Docket Item #16
BAR CASE # 2005-0182

BAR Meeting
September 7, 2005

ISSUE: Construction of a two story frame addition to the rear elevation

LOCATION: 313 South Columbus Street

Figure 1 - Proposed side elevation

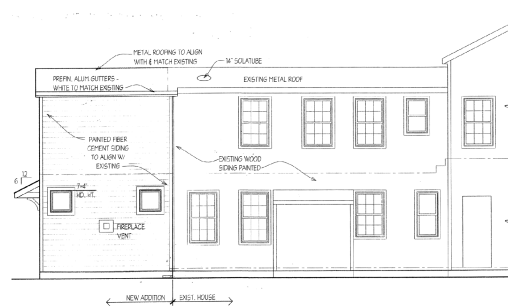
The proposed addition will comply with zoning ordinance requirements if reduced by 1.40 feet in depth to satisfy required open space requirements. Staff recommends that the addition actually be reduced by 2 feet so that the addition will still comply with zoning requirements in the event of construction error in the placement of the addition.

The sash proposed for the project are Andersen simulated divided light, with internal spacers between exterior and interior muntins, vinyl clad. The applicant proposes use of the standard 7/8" muntin profile. The *Design Guidelines* list vinyl clad windows as a discouraged type of window (Windows - Page 2). Staff recommends that the windows be wood to match the existing windows. Staff has no objections to the use of simulated divided lights on the addition.

1. That the length of the addition be reduced by 2 feet;
2. That the windows be wood simulated divided lights;
3. That smooth fiber cement siding be used;
4. That the nails not show in the installation of the siding;

Figure 2 - Proposed rear elevation

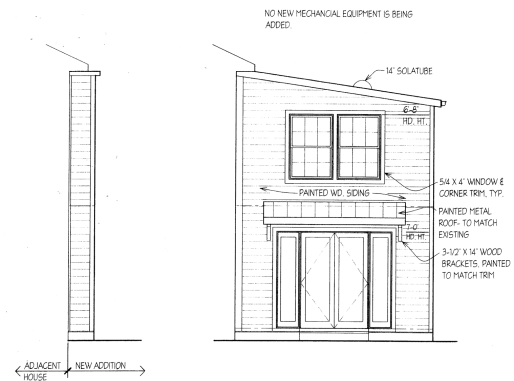
The fundamental premise of the proposal is consistent with the *Design Guidelines* for additions in most respects and is differentiated by the window openings and doors which speak to a more contemporary, but still compatible idiom.
